Product Change Notice (PCN)

PCN Number: **PCN-0450500R-01**

Product(s) Affected: MJ-2508N

PREVIOUS CUI DEVICES DETAIL / IMAGE	NEW CUI DEVICES DETAIL / IMAGE

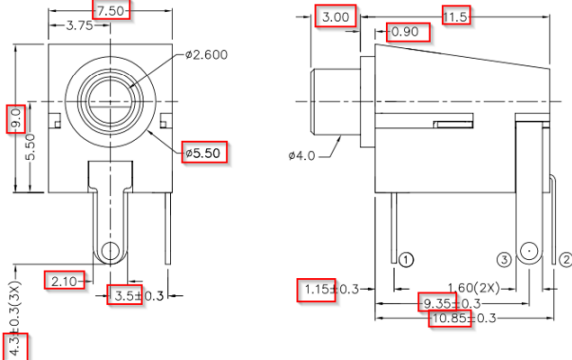
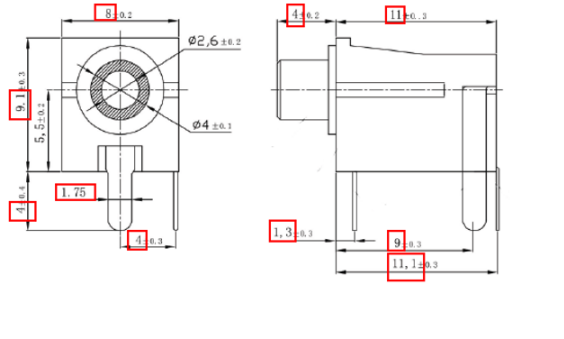
Description of Change: mechanical and material differences as shown below:

<p>Recommended PCB Layout Top View</p>	 <p>Recommended PCB Layout Top View</p>																																				
<table border="1"> <thead> <tr> <th></th> <th>MATERIAL</th> <th>PLATING</th> </tr> </thead> <tbody> <tr> <td>terminal 1</td> <td>brass</td> <td>tin</td> </tr> <tr> <td>terminal 2</td> <td>copper alloy</td> <td>tin</td> </tr> <tr> <td>terminal 3</td> <td>brass</td> <td>tin</td> </tr> <tr> <td>bushing</td> <td>brass</td> <td>nickel</td> </tr> <tr> <td>plastic</td> <td>PBT</td> <td></td> </tr> </tbody> </table>		MATERIAL	PLATING	terminal 1	brass	tin	terminal 2	copper alloy	tin	terminal 3	brass	tin	bushing	brass	nickel	plastic	PBT		<table border="1"> <thead> <tr> <th>DESCRIPTION</th> <th>MATERIAL</th> <th>PLATING/COLOR</th> </tr> </thead> <tbody> <tr> <td>terminal 1</td> <td>brass</td> <td>tin</td> </tr> <tr> <td>terminal 2</td> <td>brass</td> <td>tin</td> </tr> <tr> <td>terminal 3</td> <td>brass</td> <td>tin</td> </tr> <tr> <td>bushing</td> <td>brass</td> <td>tin</td> </tr> <tr> <td>housing</td> <td>PBT (UL94V-0)</td> <td>black</td> </tr> </tbody> </table>	DESCRIPTION	MATERIAL	PLATING/COLOR	terminal 1	brass	tin	terminal 2	brass	tin	terminal 3	brass	tin	bushing	brass	tin	housing	PBT (UL94V-0)	black

MATERIAL	PLATING																																			
terminal 1	brass	tin																																			
terminal 2	copper alloy	tin																																			
terminal 3	brass	tin																																			
bushing	brass	nickel																																			
plastic	PBT																																				
DESCRIPTION	MATERIAL	PLATING/COLOR																																			
terminal 1	brass	tin																																			
terminal 2	brass	tin																																			
terminal 3	brass	tin																																			
bushing	brass	tin																																			
housing	PBT (UL94V-0)	black
